AMENDMENT TO THE DRAWINGS

REMARKS/ARGUMENTS

FIG. 3

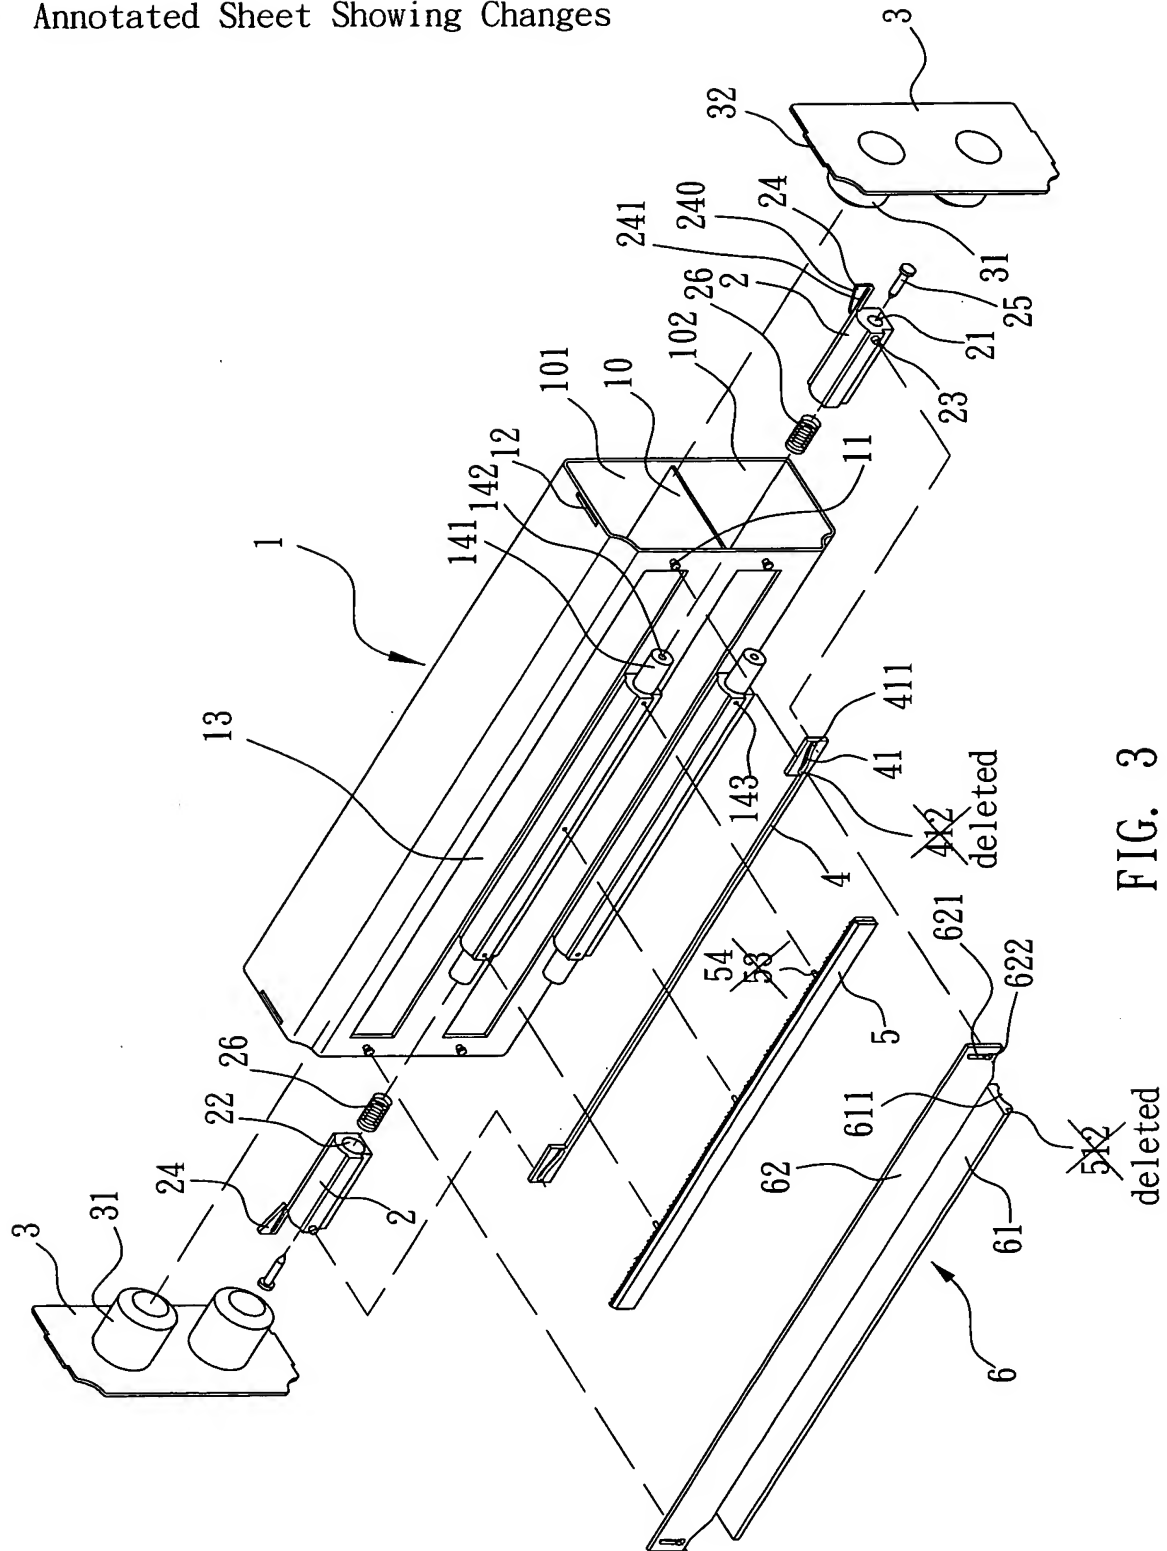
In Fig. 3, the reference number "53" is changed to --54--. In addition, the reference numbers "412" and "612" are deleted to correspond to the specification.

FIG. ~~8~~ 8

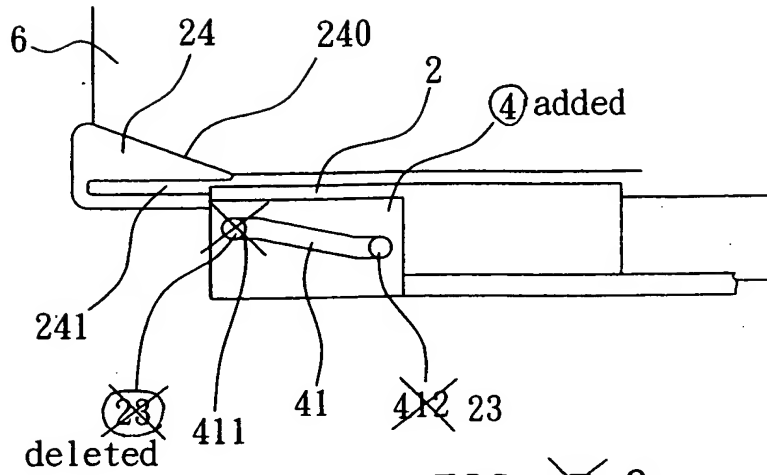
The original Fig. 7 is changed into Fig. 8, and the original Fig. 8 is changed into Fig. 7.

In the new figure 8, the guiding wedge 23 moves along the cam groove 41 and pushes the lower panel 4 upward until the guiding wedge 23 is located at a low point of the cam groove 41, and the lower panel 4 is higher than the upper edge of the cutter 5.

FIG. ~~8~~ 7

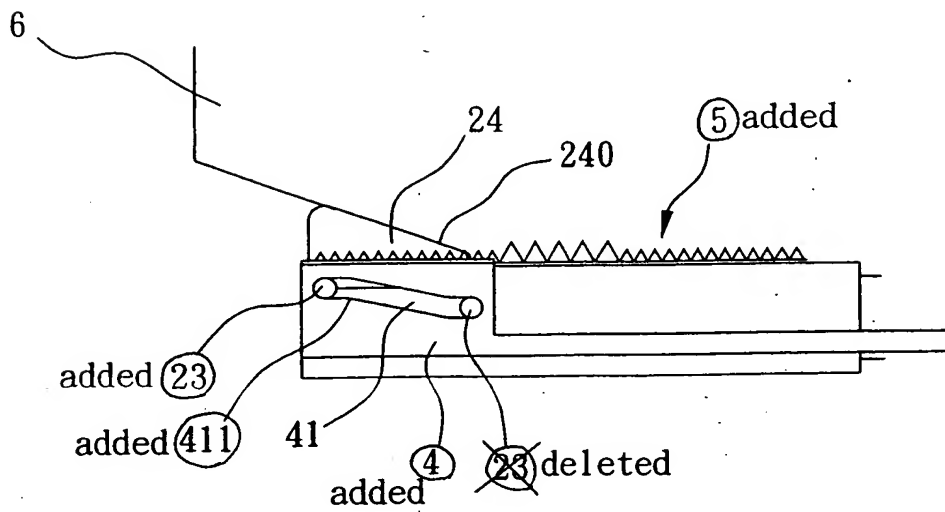
In the new figure 7, the guiding wedge 23 is located at a high point 411 of the cam groove 41, and the lower panel 4 is lower than the upper edge of the cutter 5 to expose the upper edge of the cutter 5.
